CEMVN-CD-NO-Q

18 September 2000

SUBJECT: Contract No. DACW29-99-C-0005, Lake Pontchartrain, Louisiana and Vicinity, London Avenue Outfall Canal, Parallel Protection, Floodproofing of Gentilly Boulevard Bridge, Orleans Parish, Louisiana

PLAN & PROFILE SOUTH ROADWAY

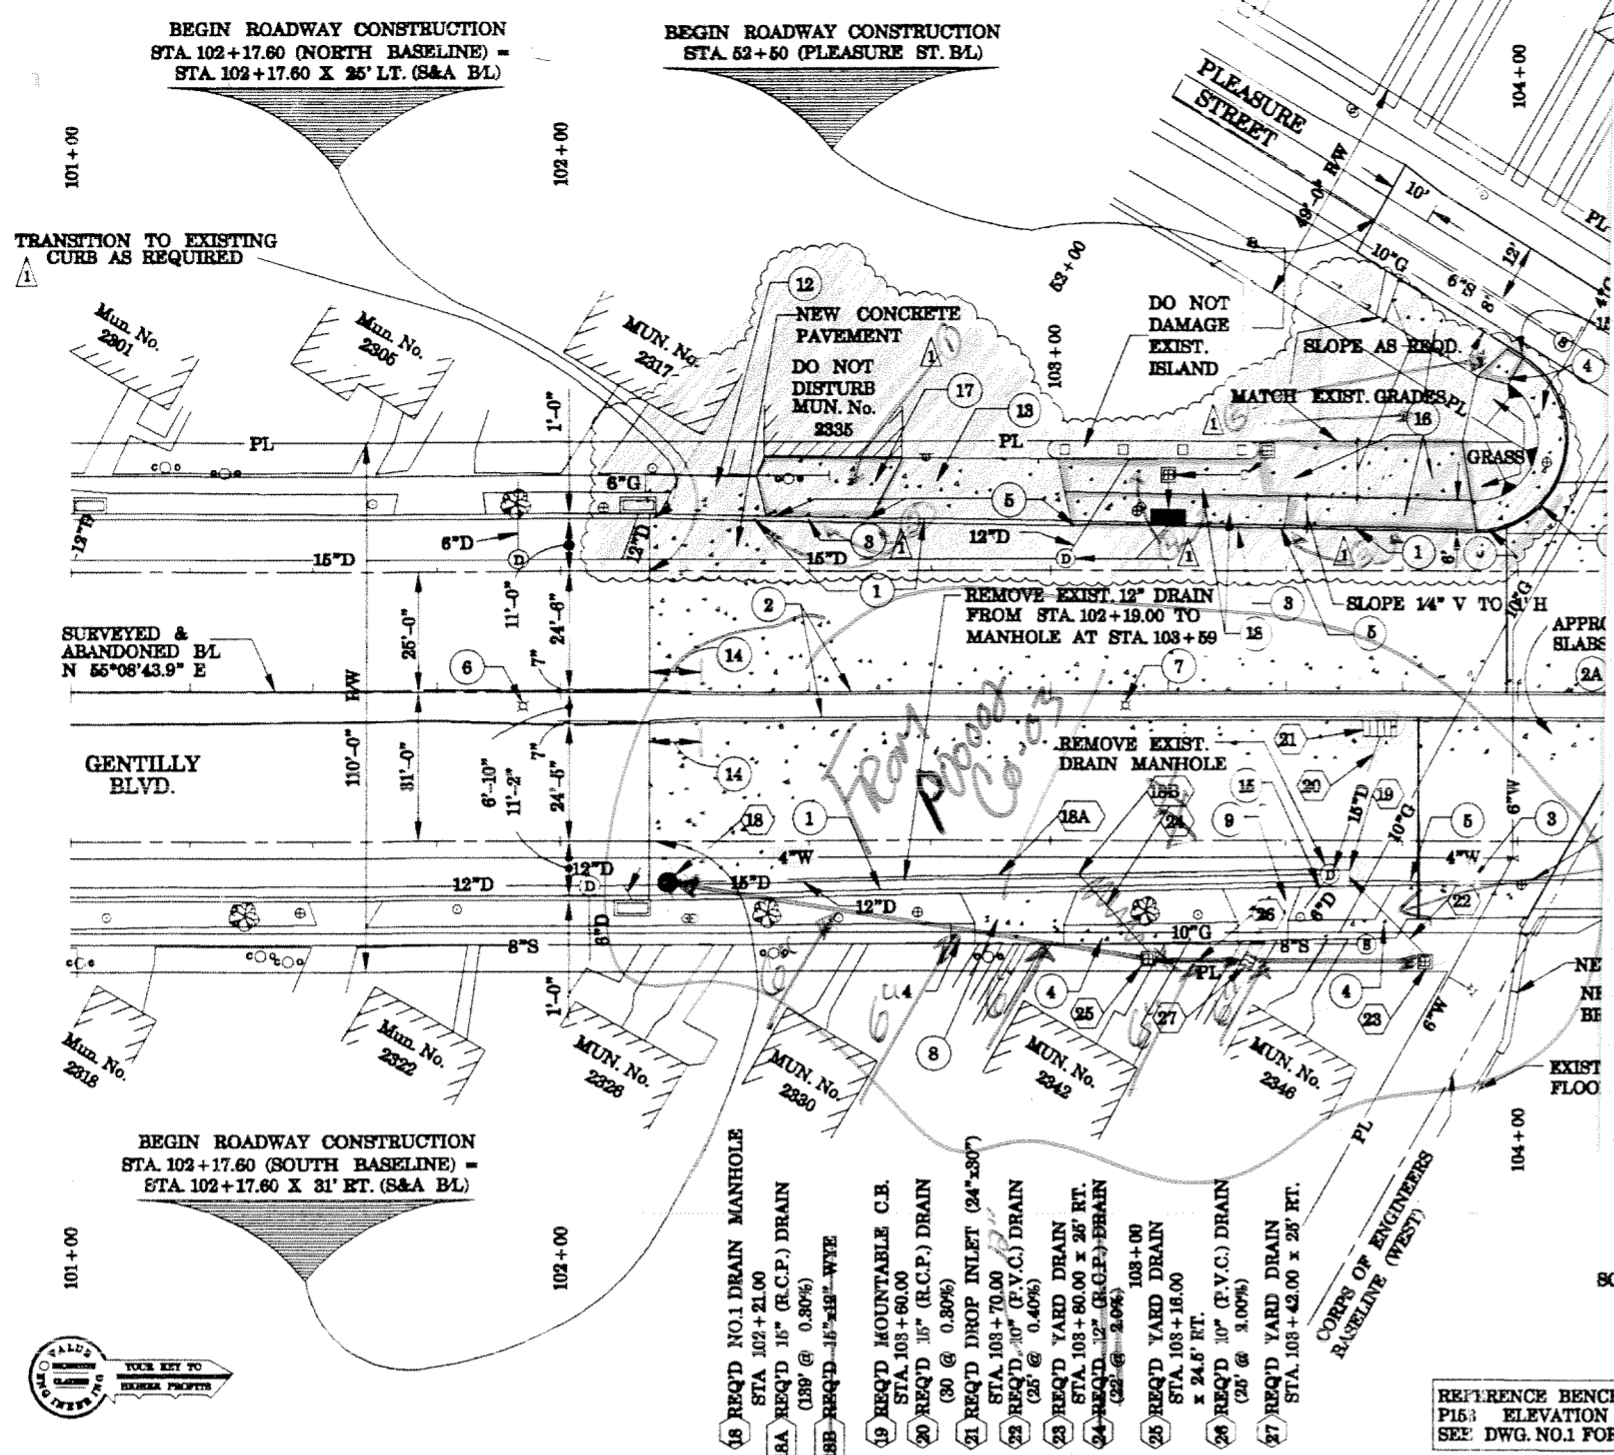
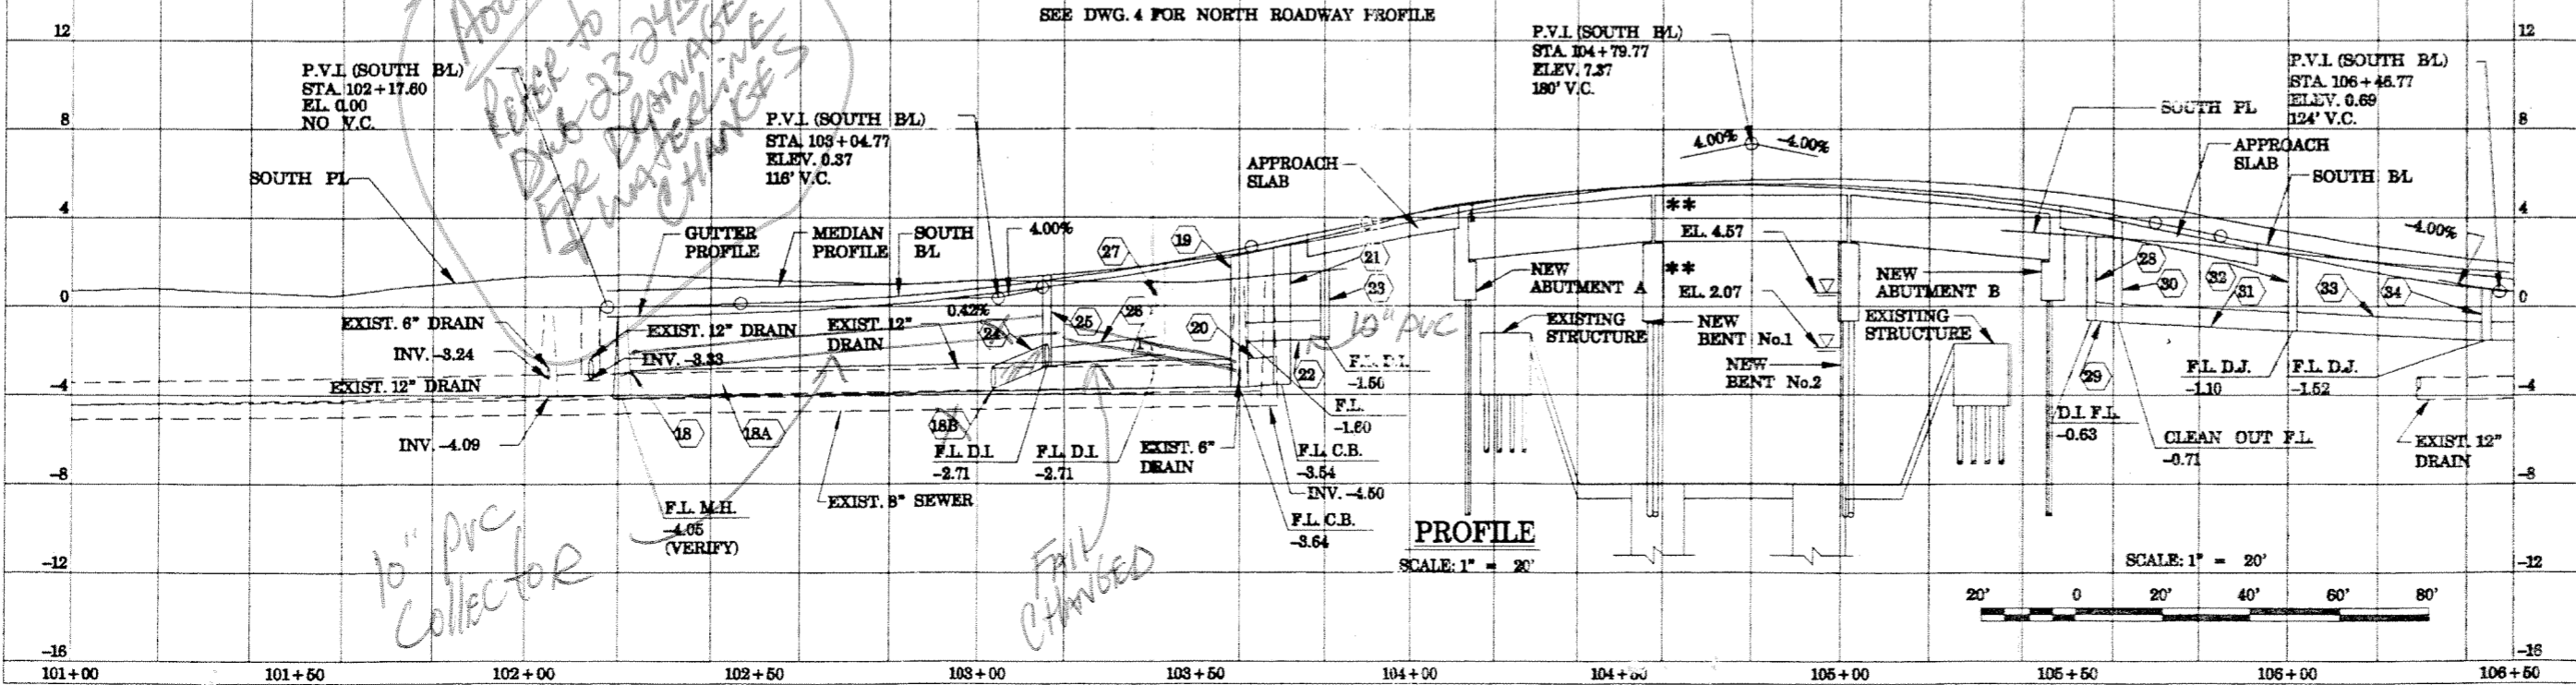
A00003
Refer to
Dwg 23-24B
for
DRAINAGE
CHANGES
10" PVC
Collector
FILL
CHANGED

- 1 Change 4" thick Concrete Sidewalk to 6" thick Residential Driveway Concrete.
- 2 Change 4" Mountable Curb & New 6" thick Residential Driveway to a 6" Barrier Curb Add two 5' Transitions.
- 3 Change 6" Barrier Curb to 4" Mountable Curb & Add transition.
- 4 Change 4" thick Concrete Sidewalk to 8" thick Commercial Driveway + Add 8" thick Commercial Driveway Between Sidewalk & Island.
- 5 Change 4" thick Concrete Sidewalk to 8" thick Commercial Driveway + Add 8" thick Commercial Driveway Between Sidewalk & Back of Island Add 15' transition between Sidewalk & Driveway + Add 6" Barrier Curb.

PLAN & PROFILE
SOUTH ROADWAY

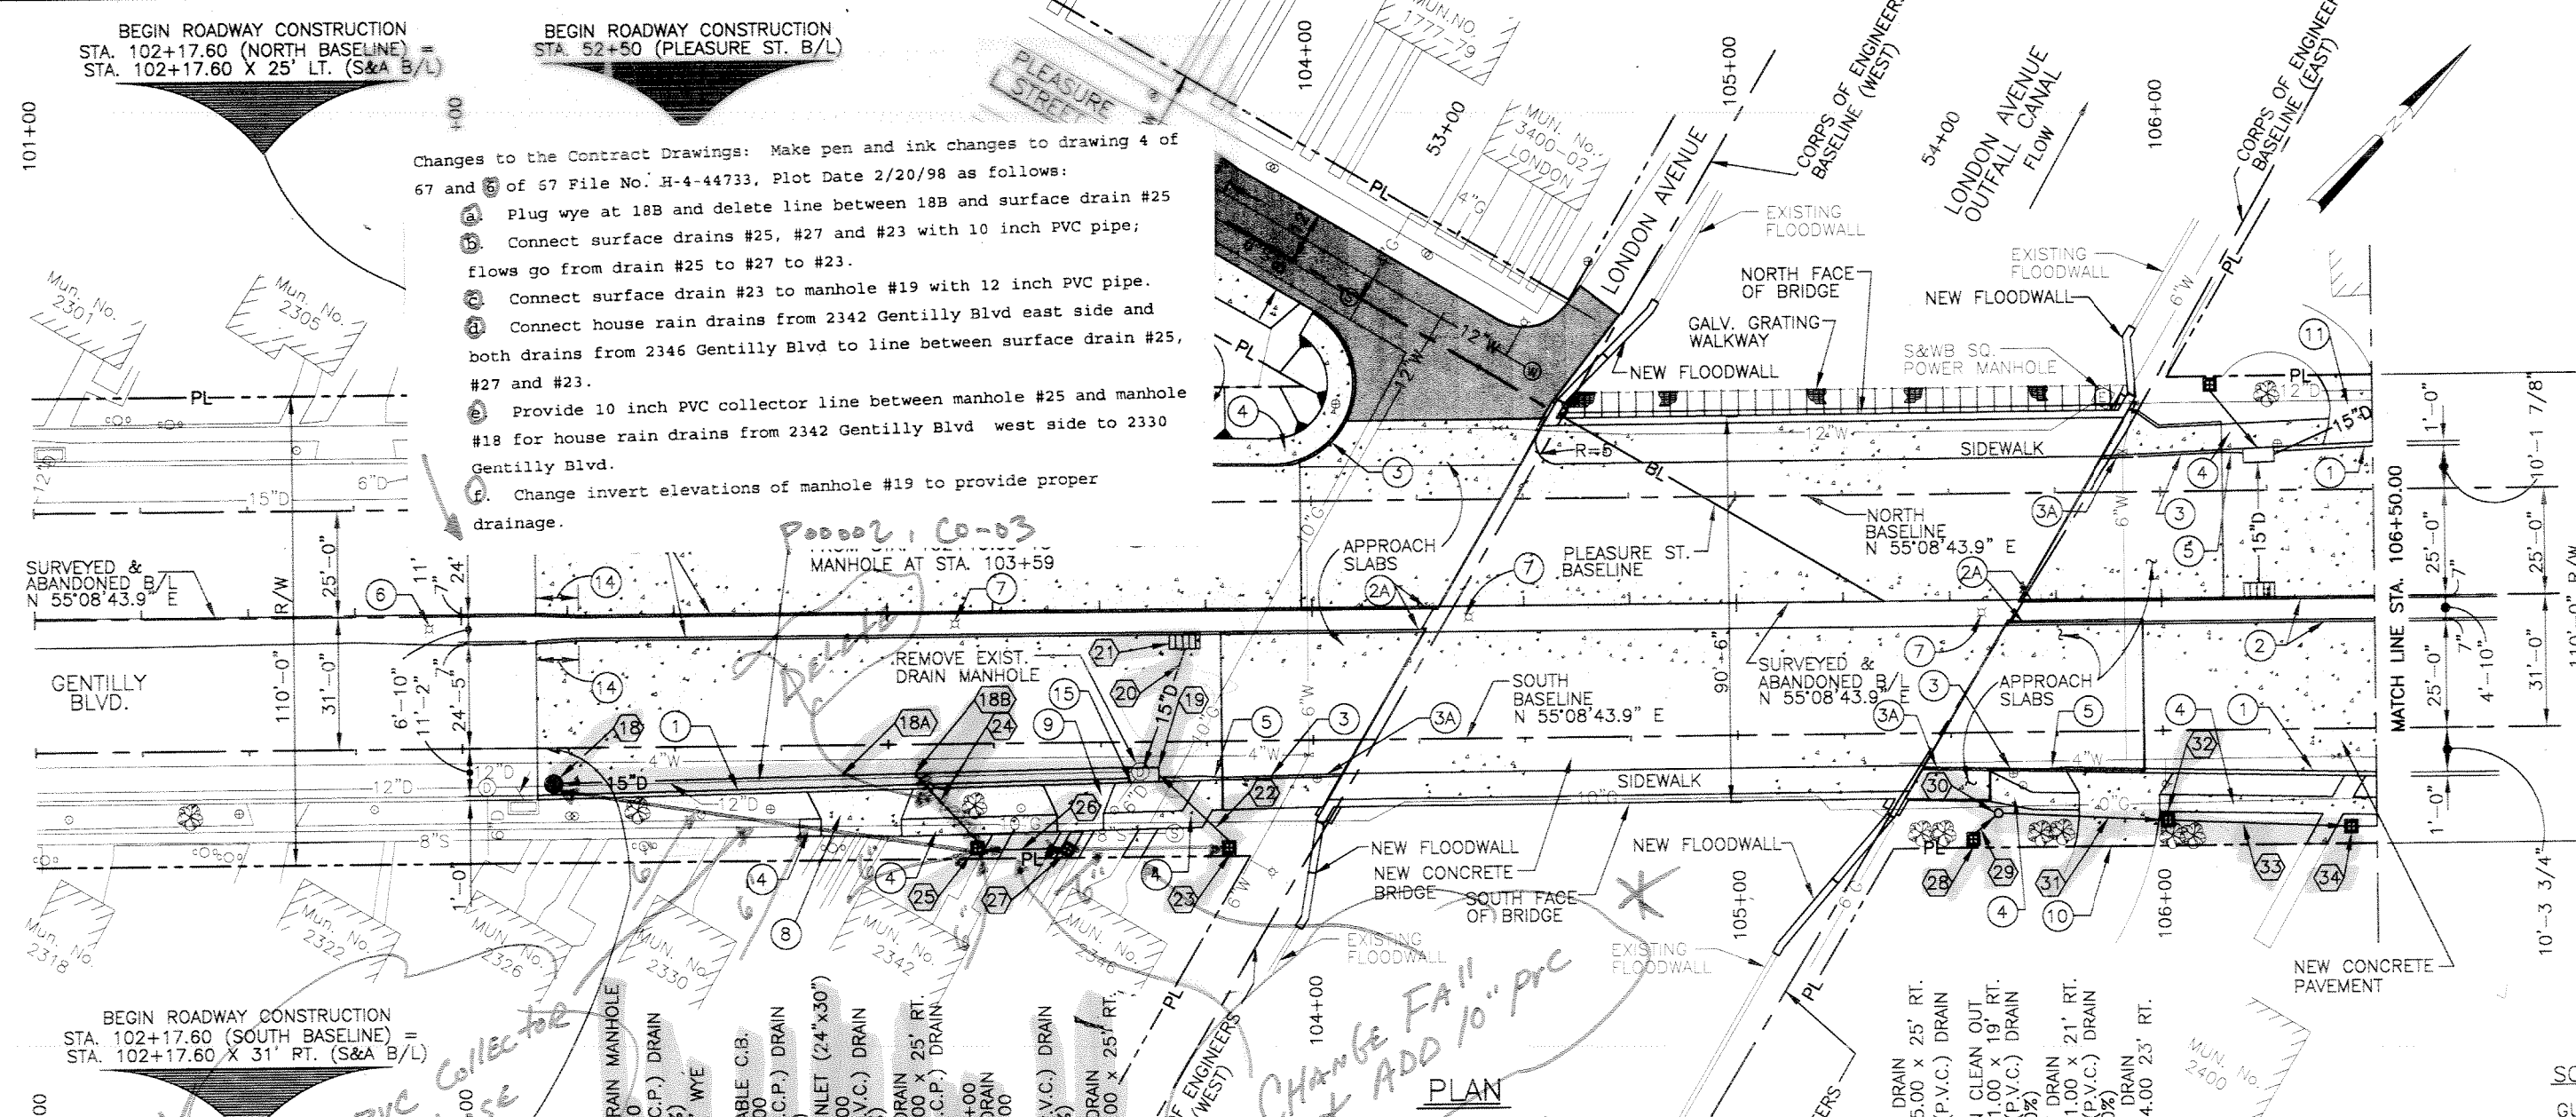
Changes to the Contract Drawings: Make pen and ink changes to drawing 4 of 67 and 5 of 57 File No. H-4-44733, Plot Date 2/20/98 as follows:

- Plug wye at 18B and delete line between 18B and surface drain #25
- Connect surface drains #25, #27 and #23 with 10 inch PVC pipe; flows go from drain #25 to #27 to #23.
- Connect surface drain #23 to manhole #19 with 12 inch PVC pipe.
- Connect house rain drains from 2342 Gentilly Blvd east side and both drains from 2346 Gentilly Blvd to line between surface drain #25, #27 and #23.
- Provide 10 inch PVC collector line between manhole #25 and manhole #18 for house rain drains from 2342 Gentilly Blvd west side to 2330 Gentilly Blvd.
- Change invert elevations of manhole #19 to provide proper drainage.

TYPICAL SECTION - GENTILLY BLVD.
STA 102+17.60 TO 103+97.48
 SCALE: 1/4"=1'-0"

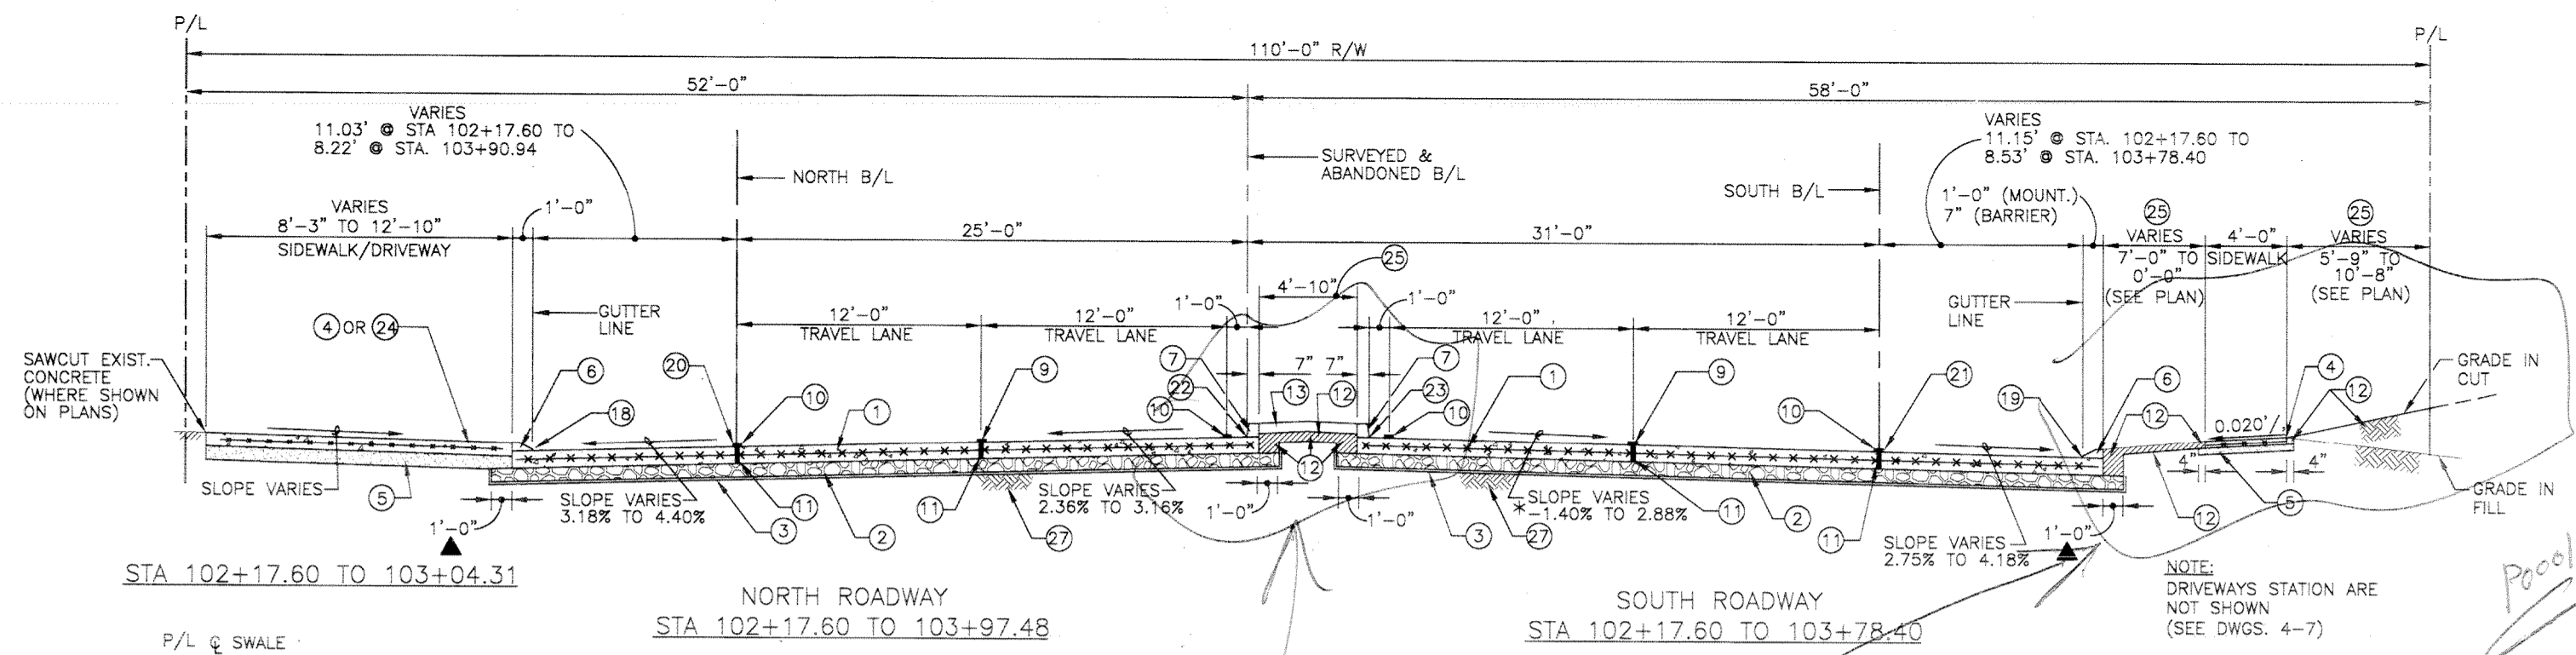
Contractor SODDED ALL AREAS
